ALERT SERVICE BULLETIN
Bell Helicopter **TEXTRON**

NO. 206-05-105

MODEL AFFECTED: 206A/B-SERIES and TH-67

SUBJECT: TAIL ROTOR TRUNNION HOUSING SEAL 535642
INSTALLATION, ONE-TIME INSPECTION OF

Figure 1. Correct orientation of seal in housing assembly

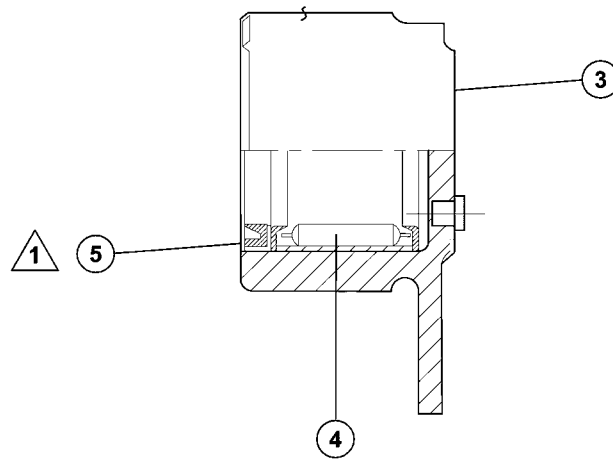
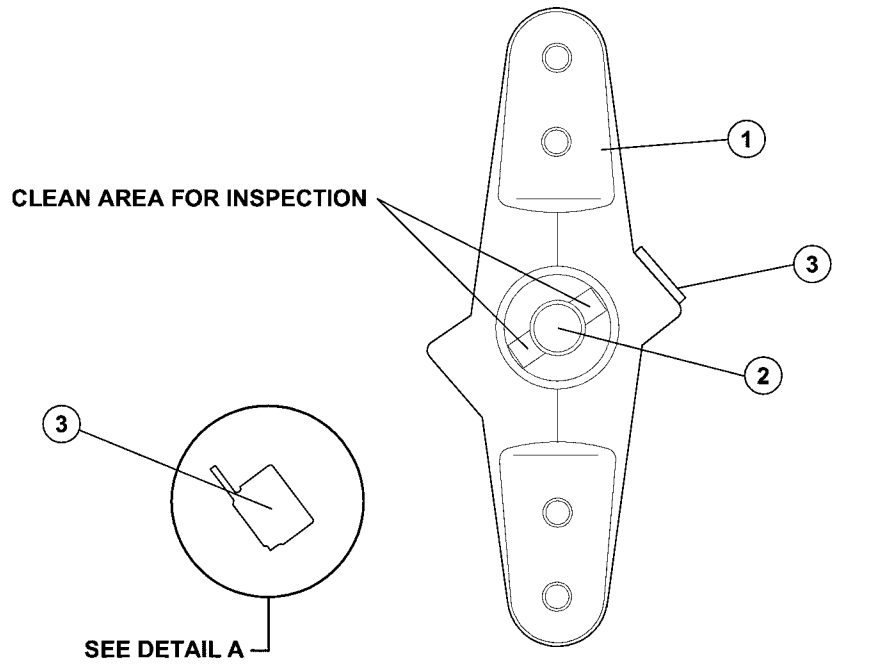
Bell Helicopter found that some 206-011-814-113 tail rotor trunnion housing assemblies sold as spares may have been assembled with the 26001-7027 seal installed backward. Incorrect installation of the seal will prevent the bearing from getting adequate lubrication and may result in the seal being pushed out of the housing assembly during lubrication.

1. Inspect new housing assembly (3, Figure 1) not installed in a hub assembly (1) for correct seal (5) installation. If the housing assembly (3) is found with the seal (5) incorrectly installed, return the defective housing assembly (3) to Bell Helicopter and order a new housing assembly (3).
2. Inspect new housing assembly (3) installed in tail rotor hub assembly (1) for correct seal (5) installation. If the housing assembly (3) is found with the seal (5) incorrectly installed, perform PART III a. of this Alert Service Bulletin.
3. Inspect housing assembly (3) installed in a hub assembly (1) with time in service for correct seal (5) installation. If the housing assembly (3) is found with the seal (5) incorrectly installed, perform PART III b. of this Alert Service Bulletin.

1. Using a hand grease gun, purge grease (C-001) from bearing (4), by pumping grease into fitting, NAS 516 of housing assembly (3).
2. If normal purging of grease (C-001) from the bearing (4) can be achieved and the seal is not pushed out of the housing assembly (3) during lubrication, the seal performance in the new housing assembly (3) is acceptable and the helicopter may be returned to service. Make an entry in the Helicopter Records to show that Part II of this Alert Service Bulletin has been accomplished.
3. If restriction is felt and no grease is being purged from the bearing (4) through the seal (5) lip, perform PART III c. at your convenience but no later than the next scheduled lubrication.

1. Remove the tail rotor hub and blade assembly from the helicopter. Refer to the BHT-206A/B-SERIES MM.
2. Replace affected housing assembly (3) and both trunnion (2) inner races. Refer to the BHT-206B3-CR&O or to the BHT-206A/B-CR&O as applicable.
3. Re-install the tail rotor hub and blade assembly on the helicopter. Refer to BHT-206A/B-SERIES-MM.
4. Ground-run the helicopter and perform a tail rotor balance check. Refer to BHT206A/B-SERIES-MM or the TB 206-96-163.
5. Make an entry in the Helicopter and the Component Historical Records to show that Part III c. of this Alert Service Bulletin has been accomplished.

NOTE
 Lip of seal facing toward the tail rotor gearbox output shaft.
Correct installation shown.
